SUBJECT: W.P. 275-64-2, Dundas Interchange,
Highway No. 27, District No. 6.

FOUNDATION INVESTIGATION REPORT

The Proposed Bridge #2, Bridge #9,
And W.B. Basketweave,
Hwy. #27 and Dundas St. Interchange,
District #6 (Toronto).

Hwy. #27 and Dundas St. Interchange
and C.P.R. Overhead North of Q.E.W.
and Hwy. #27 Interchange.
W.J. 65-P-104 and W.J. 66-P-103,
District No. 6 (Toronto).

We have reviewed Preliminary Plan D-6196-P1 for
the above mentioned structures.

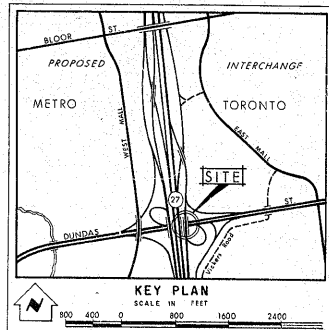
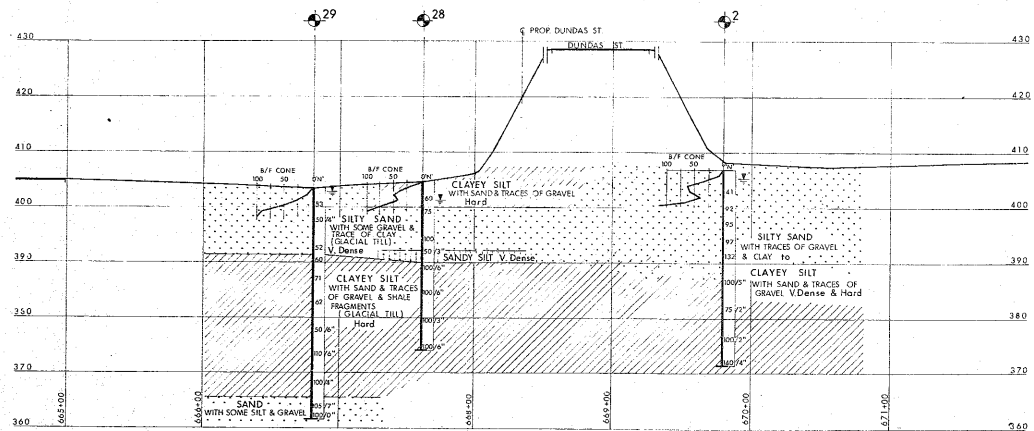
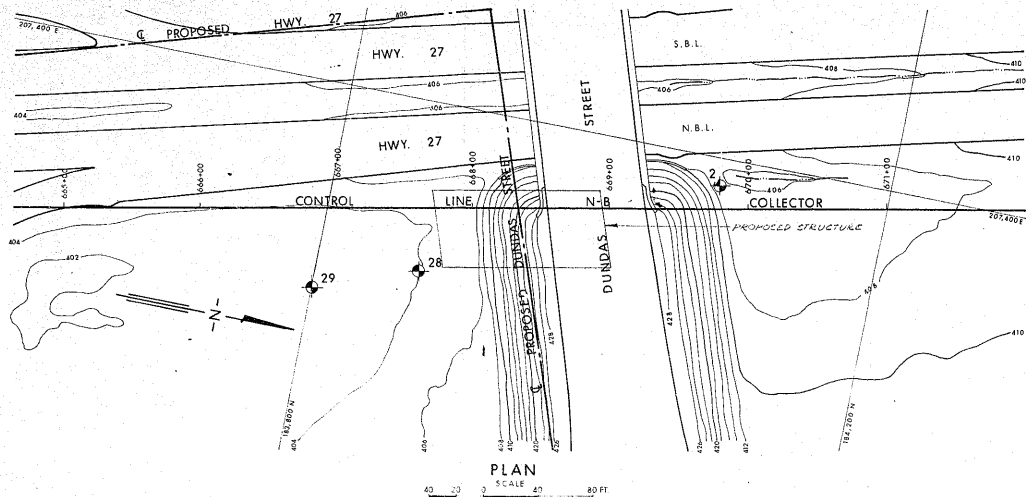
we have no comments.
